INDESIT company

BCS313AVEI
BCS313AVEIS

F027595
F027596
F029149
F029150

0522067: SEALS FOR DOORS FOAMED AS ONE PIECE

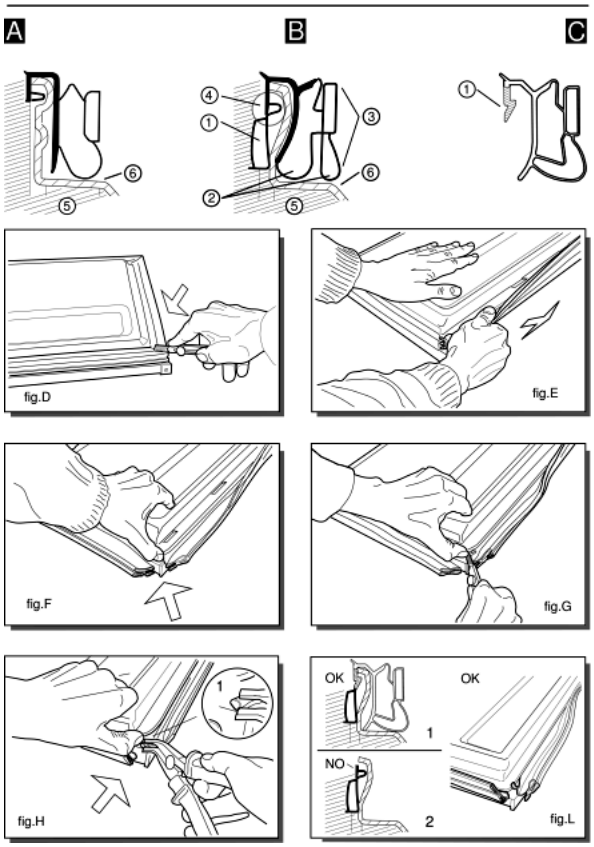
Various types of gaskets with different profile, as shown in figures (A) and (B), are used to fix the door (fig. A-5; B-5) and the inner door (fig. A-6; B-6) on the block foamed doors of combined freezers and refrigerators.
---Ilpea profile 245; 179; 412 (fig.A)
---Ilpea profile 287 (fig.B)
When replacing gaskets with profiles 245; 179; 412 these are fixed with screws (2 per corner) to the door.
Gaskets with profile 287 can not be used as spare parts but are designed to house the Ilpea type 900 gaskets (see figure C).
When replacing the gasket (287), once it is removed you will find a pocket (fig. B-1) between the door and inner door.
The rigid tooth (fig.C-1) of the gasket (900) is inserted inside between the pocket and the inner door, doing away with the need for screws.
Gasket with profile 287 is easy to identify since it has an exterior double edge (fig.B-2) which acts as a cushion when the door is closed.

To replace this gasket, follow these steps:
---Dismount the door and cut the four corners of the gasket along the joint (fig.D);
---lift the gasket and pull it carefully along its full length without tearing it (fig.E).
The purpose here is to detach the inner door slightly from the foam along the exterior edge for a depth equal to that of the gasket (fig.B-3);
---lift the corner of the inner door slightly, prising it up with your thumb (fig.F). Do not use a tool which might break the inner door;
---continue cutting the gasket inside the inner door for about 6 mm (fig.G);
---push in the tip of the pliers (type USAG N131) and pull outwards until you see the top edge of the pocket (fig. B-4) which is empty (fig.H-1);
---if you carry out this operation correctly (fig.L) you will be able to pull off the top edge of the pocket for the full length of the door.
If the gasket tears before the top edge (fig. L-2) you should repeat this operation from the other corner of the door.

---once the gasket (287), has been removed the space above the pocket (fig. L-1) can house the rigid tooth (fig. C-1) of the gasket 900.
When you fit this gasket ensure that it lies flush against the edge for the full length of the door.
If the rigid tooth is difficult to fit, eliminate any residues of foam between the door and the inner door in the gasket area.
fig.5131549A

n1030064: Elimination of sensor cage on 2002 range built-in fridge-freezers models BCS313

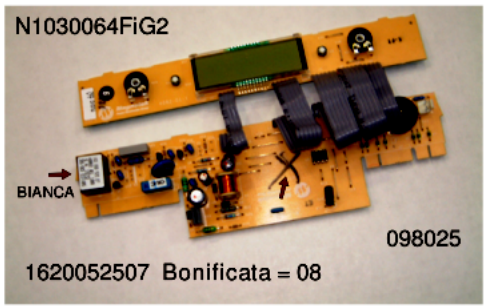
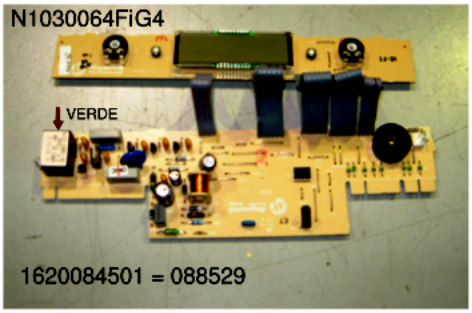
In April 2003 (serial no. 30407.0001) the Carinaro factory eliminated the cage protecting the fridge air sensor and moved the sensor 5-6 cm back on Ariston built-in electronic fridge-freezers.

This structural modification has involved the use of new electronic cards with warmer setting, because the sensor is less sensitive in the new position than in the previous more forward position with cage.

The Magnetek cards 162000524… (4083/PINK) and 162000525… (4082/WHITE) currently in stock in the Fabriano spare parts warehouse have all been replaced in order to be aligned with that used by production to date. These cards have been highlighted (see photo) with the marker pen, while the Magnetek codes (not higher than 162000524.06 and 162000525.07) are shown on the plates.
They will be managed with the following new Sat codes to enable correct ordering with respect to the previous ones.

The previous cards, with colder settings, do not have any highlighted marks and continue to be managed with the same Sat code (089759 and 088529=143093 ROHS) and must only be used on models with fridge air sensor in forward position and complete with cage.
Also, card 16200084501 will be managed with code 088529=143093 ROHS (4082/GREEN), currently used on the self-supporting fridge-freezer, which has the same settings as the previous card 16200052507 (4082/WHITE); whereas a card with red stamp on the pink plate (see photo) will be managed with code 089759.

Since November, electronic cards, with warmer settings, give the code 16200052407 for 4083/PINK and 16200052508 for 4082/WHITE on the plate, and must only be used on models with fridge air sensor without cage and in the back position.

.
New parts
098024 = (143091 ROHS) CARD (MAGNETEK 4083/PINK) new (no-frost models without cage)
098025 = (143092 ROHS) CARD (MAGNETEK 4082/WHITE) new (static models without cage)

Parts replaced
089759 - CARD (MAGNETEK 4083/PINK) 220-240/50 + red stamp (no-frost models with cage)
088529 = (143093 ROHS) CARD (MAGNETEK 4082/PINK) 220-240/50 (static models with cage)

n1030100: New fixing bracket for combined 310-330 litre built-in models (Carinaro)

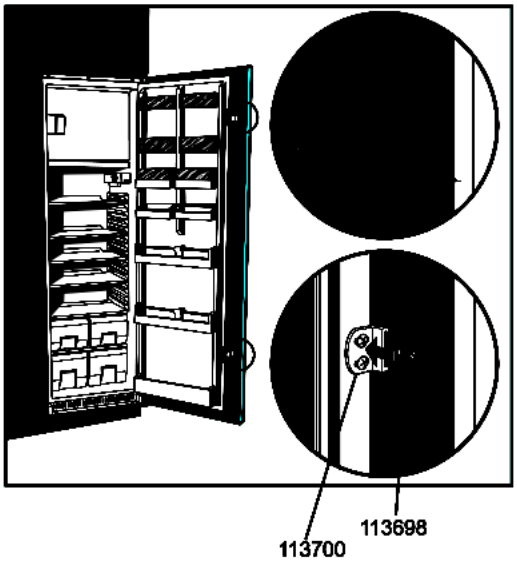
Since January 2006 (s/n 60123.0001) the fixing bracket, fitted on the cabinet, has been modified to strengthen the top hinge pin area.
The modification consists of having replaced the plastic bush with a threaded metal bushing (12x15) welded to the fixing bracket.
The new fixing bracket can also be fitted on premodification models.

144558 - HINGE-M8 FIXING BRACKET WHITE (LXDXH 540X90X22)

075191 - HINGE-FIXING BRACKET WHITE (LXLXH)540X90X22
057839 - WHITE BUSH (27X15X4.6) FOR PIN M8
110027 - WHITE BUSH 27X15X8) FOR PIN M8
